#### **MAINE TURNPIKE AUTHORITY**

#### ADDENDUM NO. 2

#### **CONTRACT 2018.10**

Bridge and Culvert Repairs 4 Locations
Danville Corner Road Underpass (Mile 75.8)
Curtis Brook Culvert (Mile 87.49)
Fisher Farm Road Underpass (Mile 87.5)
Center Road Underpass (Mile 91.9)

FFIC CONTROL DETAILS
SHEET 1a OF 2

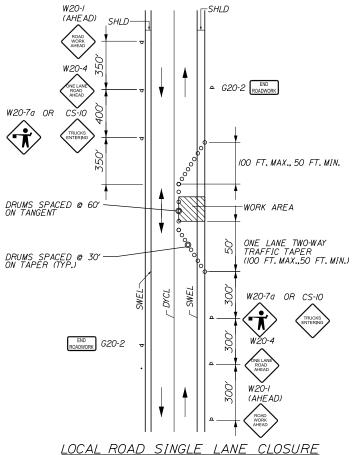
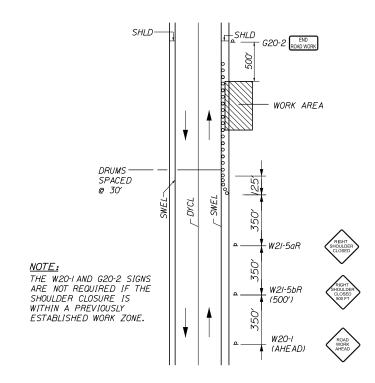
Plan Sheet 4A of 28, "Traffic Control Details Sheet 1A of 2" is added to the set after sheet 4.

- Answer: Yes. Flaggers have been added to the contract. Please see the attached revised P-sheets and Plan Sheets 4a, 9, and 10.
- Question 6: Why are sandbags not permitted for the Curtis Brook Culvert work?

> TRAFFIC CONTROL DETAILS SHEET 2 OF 2

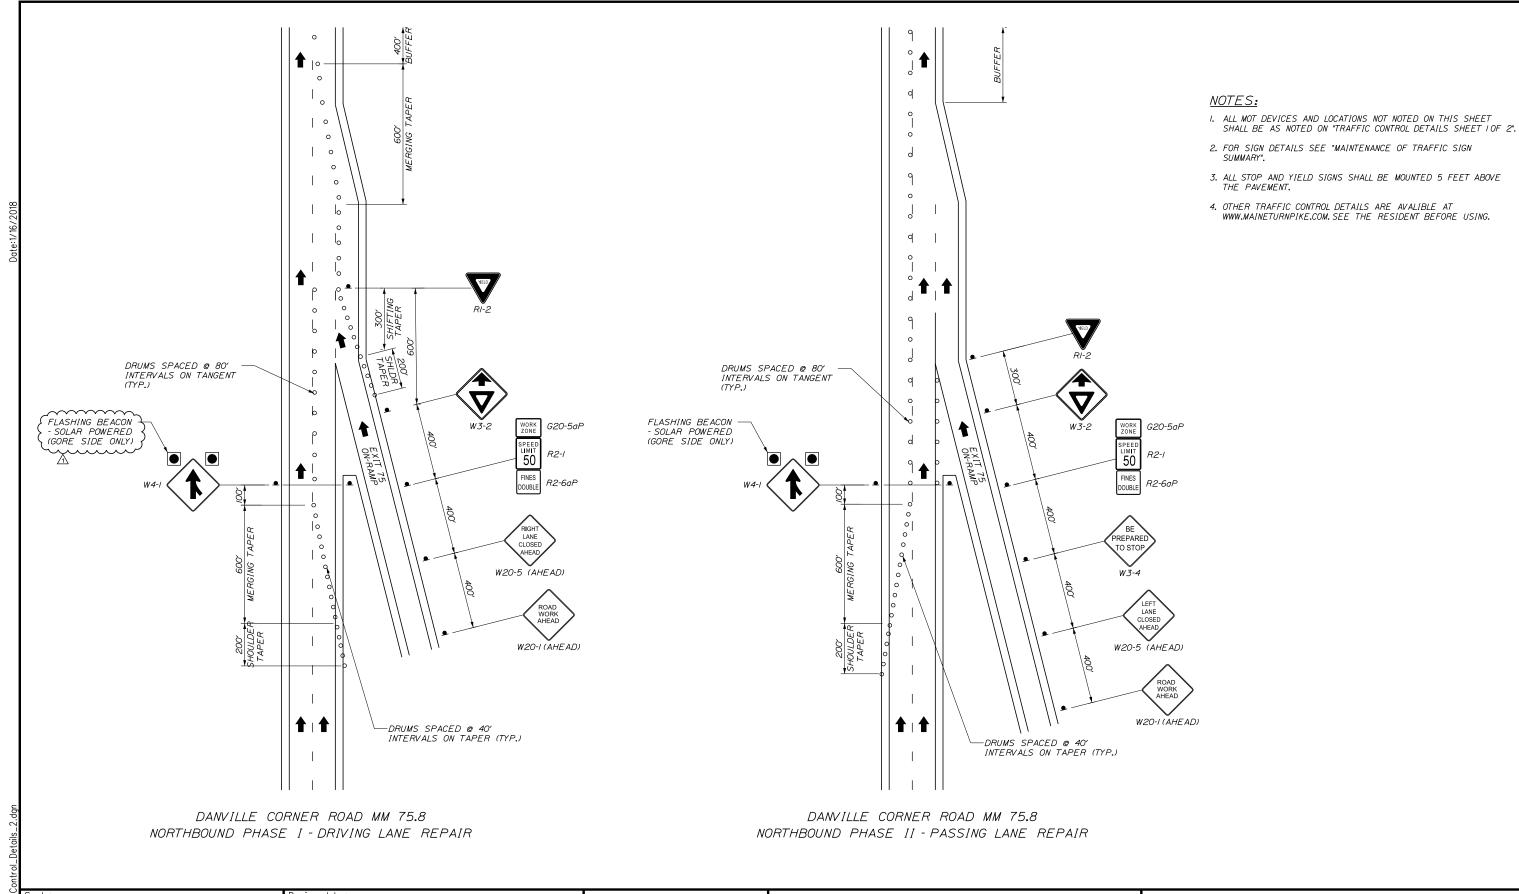
Plan Sheet 5 of 28, "Traffic Control Details Sheet 2 of 2" is deleted and replaced in its entirety with the attached revised sheet 5.

1 Correct beacon text
